SUBJECT: ISSUE RESOLUTION STATUS REPORT (KEY TECHNICAL ISSUE:
CONTAINER LIFE AND SOURCE TERM, REVISION 2)

Revision 2

Change history of "Issue Resolution Status Report, Key Technical Issue: Container Life and Source Term"

Figure 6. Effect of chloride concentration on repassivation potential of three different CRAs

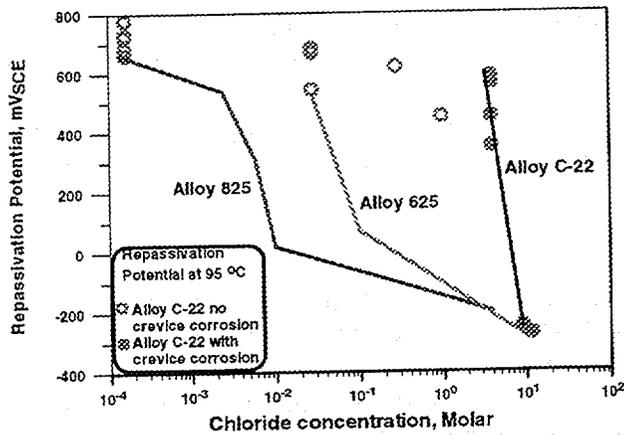
- (3) The critical temperature for localized corrosion is assumed in the TSPA-VA to be independent of chloride concentration or corrosion potential. As shown in Figure 6, the critical temperature is dependent on both chloride concentration and potential.
